2.4S.13 Accidental Releases of Radioactive Liquid Effluents in Ground and Surface Waters

The following site-specific supplement addresses COL License Information Item 2.21.

Figure 2.4S.13-2 Groundwater Transport Pathways

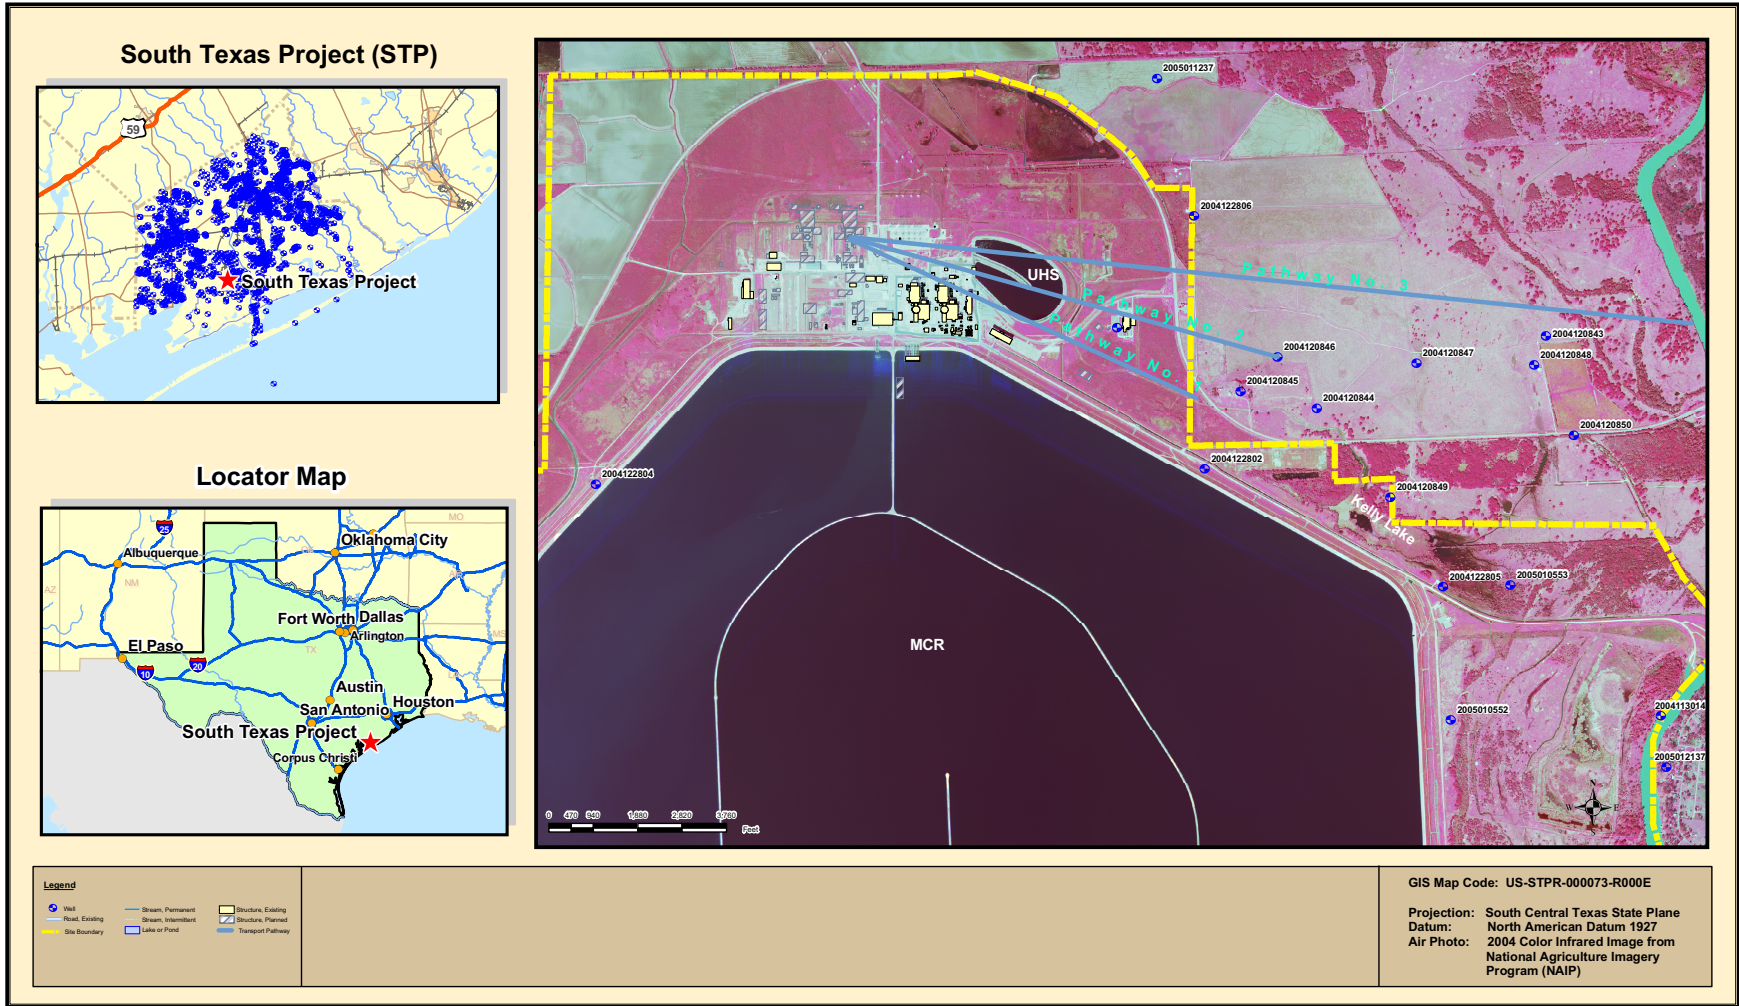
Figure 2.4S.13-2 shows these pathways in relation to the STP site. The excavation required for the construction of STP 3 & 4 penetrates into both the Upper and Lower Shallow Aquifer zones, but is above the thick sequence of clay and silt that separates the Shallow Aquifer from the more productive Deep Aquifer. ~~Because The Upper Shallow Aquifer would be impacted by the postulated LCW release as it occurs at the base of the Upper Shallow Aquifer. In addition, considering~~ there is a downward, vertical hydraulic gradient between the Upper and Lower Shallow Aquifer zones, and the backfilled excavation ~~encounters~~, which may hydraulically connect both aquifer

zones, ~~the most a~~ likely groundwater pathway for an accidental release ~~is~~ would also be in the Lower Shallow Aquifer.

- Pathway 1 includes two scenarios: a) discharge to the unnamed tributary at the east site boundary from the Upper Shallow Aquifer; and b) discharge to a hypothetical off-site water well installed within both the Upper and Lower Shallow Aquifers at the east site boundary. The well, which could serve as a domestic drinking water well, would represent a direct human exposure.

- Pathway 2 terminates at an existing 80-foot deep, off-site Shallow Aquifer livestock watering well. This well is assumed to penetrate both the Upper and Lower Shallow Aquifer and to possibly also be used for domestic water supply. The well is reported to pump 200,000 gallons per year (Reference 2.4S.13-4). This well could be a direct exposure pathway if used for human consumption.

- Pathway 3 terminates at the Colorado River. The Colorado River is believed to flow within a channel incised into both the Upper and the Lower Shallow Aquifers. This would also be an indirect exposure pathway through animals (livestock watering) and crops (irrigation). Note that the Colorado River is not used as a source of potable water downstream of the site area (Subsection 2.4S.1).

Pathway ~~2~~3 represents a combined groundwater/surface water pathway, and the influent groundwater concentrations would be reduced by dilution from unimpacted surface water mixing in the Colorado River. The most conservative case would be a release during low flow conditions. The minimum 7-day low flow rate over the period from 1948 and 2006 is approximately 0.5 cfs (Subsection 2.4S.11.1).
